No.	Revision	<u>Name</u>	<u>Scale</u>
PA-000	#	Drawing Register	N.T.S
PA-100	#	Existing Site Plan/Site Analysis	1:100 @ A1, 1:200 @ A3
PA-101	#	New Site Plan/Design Response	1:100 @ A1, 1:200 @ A3
PA-102	#	Landscape Plan	1:100 @ A1, 1:200 @ A3
PA-103	#	Landscape Specification and Detail	
PA-200	1	Basement Floor Plan	1:100 @ A1, 1:200 @ A3
PA-201	2	Ground Floor Plan	1:100 @ A1, 1:200 @ A3
PA-202	2	First Floor Plan	1:100 @ A1, 1:200 @ A3
PA-203	1	Second Floor Plan	1:100 @ A1, 1:200 @ A3
PA-204	#	Roof Plan	1:100 @ A1, 1:200 @ A3
PA-205	#	Shadow Diagrams	1:200 @ A1, 1:400 @ A3
PA-206	#	Shadow Diagrams	1:200 @ A1, 1:400 @ A3
PA-207	1	Shadow Diagrams	1:200 @ A1, 1:400 @ A3
PA-400	#	Proposed West Elevation	1:100 @ A1, 1:200 @ A3
PA-401	1	Proposed East Elevation	1:100 @ A1, 1:200 @ A3
PA-402	2	Proposed North Elevation	1:100 @ A1, 1:200 @ A3
PA-403	1	Proposed South Elevation	1:100 @ A1, 1:200 @ A3
PA-500	#	Section A-A	1:100 @ A1, 1:200 @ A3

ect Title	Drawing Title			
405 Dandenong Road //alvern East		g Regis	ter	
	Print Date	7/05/2021	Page No.	Revision
	Project Date	23/04/2018	PA-000	2
COPYRIGHT: The design & these drawings are the sole property of John Henry Architects	Drawn by	YD/DM		_
d

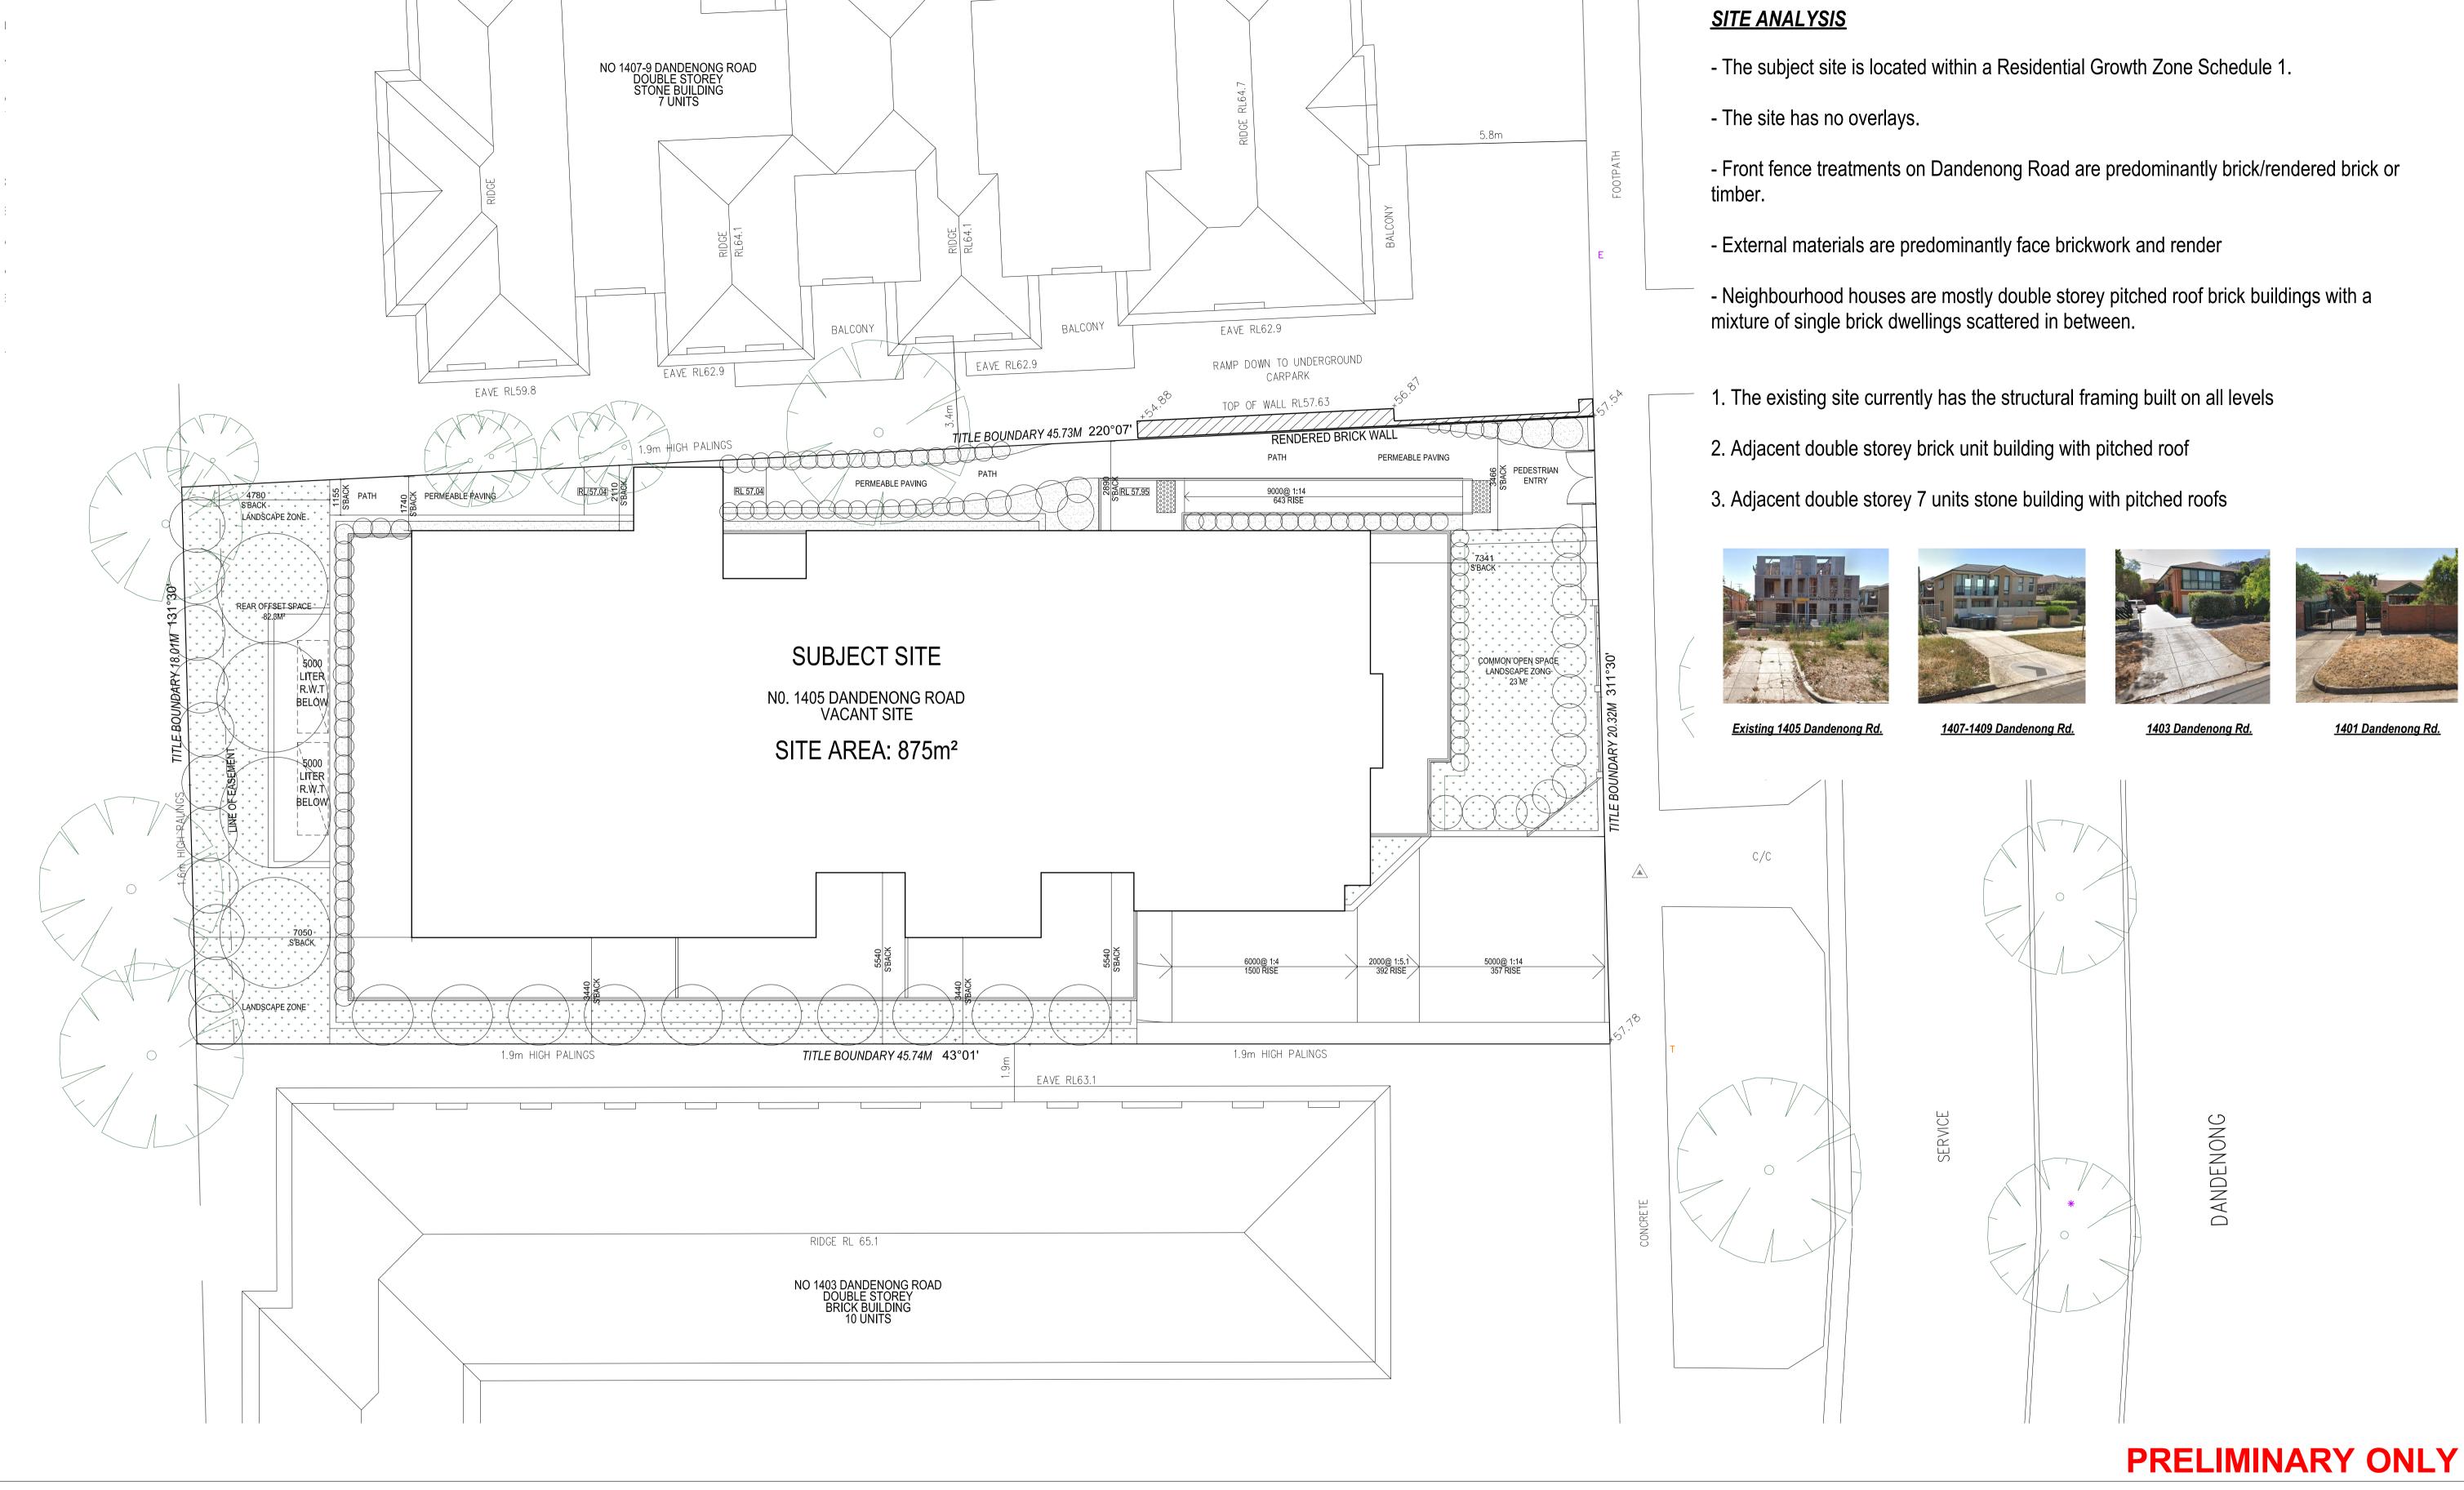
-Bathrooms adjusted to have 820MM openings as per design option B
-All bedrooms adjusted to have 850MM openings as per standard B41

-Storage calculations have been added -Apartment 9 balcony has been amended to achieve 13.5m²

-Apartment 5 balcony increased to 2M width as per standard B43

VEE IIIIII VAIX	
rawing Title			
Shadow	[,] Diagrai	m	Project North
rint Date	7/05/2021	Page No.	Revision
roject Date	23/04/2018	PA-207	1
rawn by	YD/DM		
hecked by	JH	Scale 1:200@A1, 1:500 @ A3

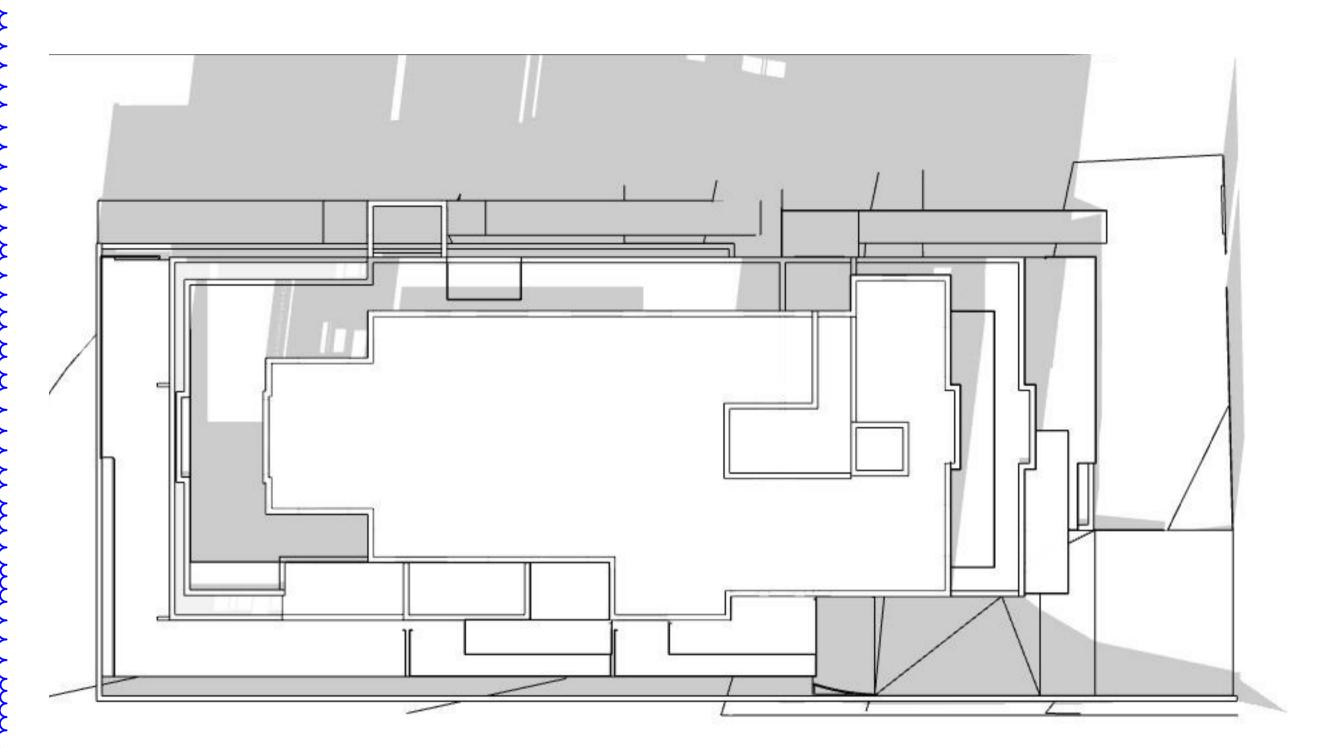
-New shadow diagrams added to show communal open space receiving a minimum of two hours of sunlight as per Standard B37

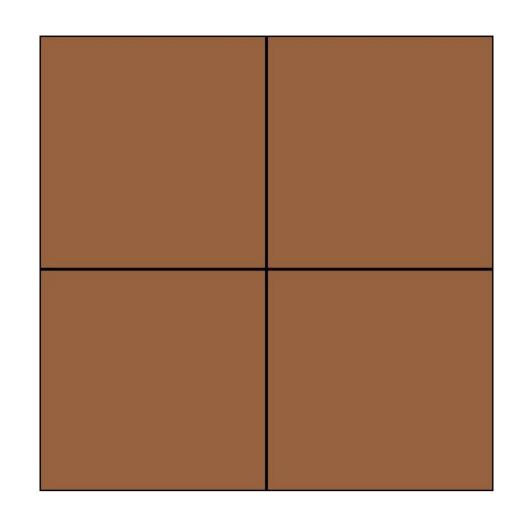
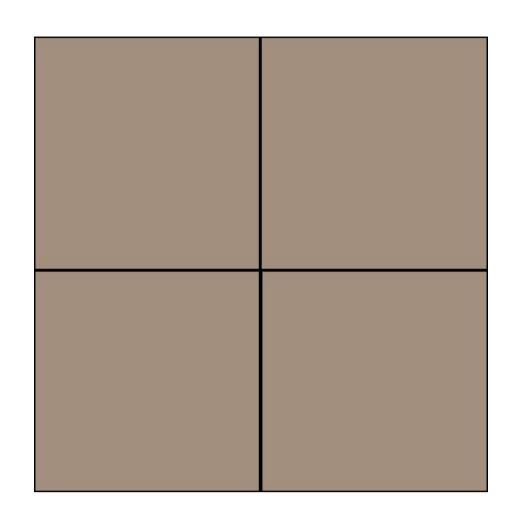
-ESD annotation has been added
